service bulletin

STERN DRIVES/INBOARD ENGINES

NUMBER: 80-11 DATE: 8/26/80

- A. MCM 485 Wide Open Throttle RPM
- B. MCM 485 Power Steering Pump Reservoir Cap
- C. MCM 485 Distributor Advance Weight Springs
- D. MCM 470/485 Flame Arrestor Damage

FIGURE 1

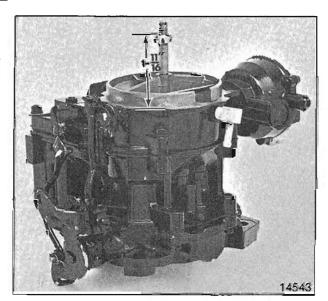
A few reports have been received of MCM 470/485 flame arrestor top covers breaking at the "stamped identation" around the retaining stud. This type of damage can be caused by incorrect positioning of the flame arrestor support nut (lower nut) on the center stud. The top of the support nut must be 1-11/16" from the flame arrestor mounting surface on the carburetor (refer to Figure 1). Check this dimension on any carburetor with which flame arrestor breakage has occurred.
